Product Change Notification / LIAL-02XWMF227

CCB 5129 Initial Notice: Qualification of G700 as a new molding compound material and NiPdAuAg with roughened as a new lead frame DAP surface prep for selected MIC7300, MIC2778, MIC833, and MIC2779 device families available in 5L SOT23 package assembled at STAR assembly site.

PCN#: LIAL-02XWMF227

Lead Frame Comparison

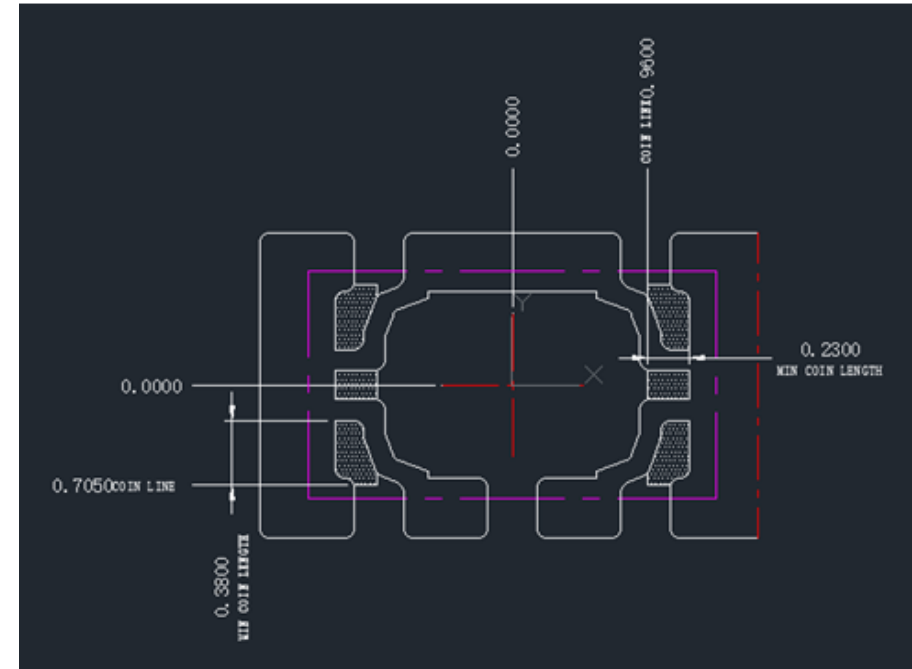
Description of Change:Qualification of G700 as a new molding compound material and NiPdAuAg with roughened as a new lead frame DAP surface prep for selected MIC7300, MIC2778, MIC833, and MIC2779 device families available in 5L SOT23 package assembled at STAR assembly site.
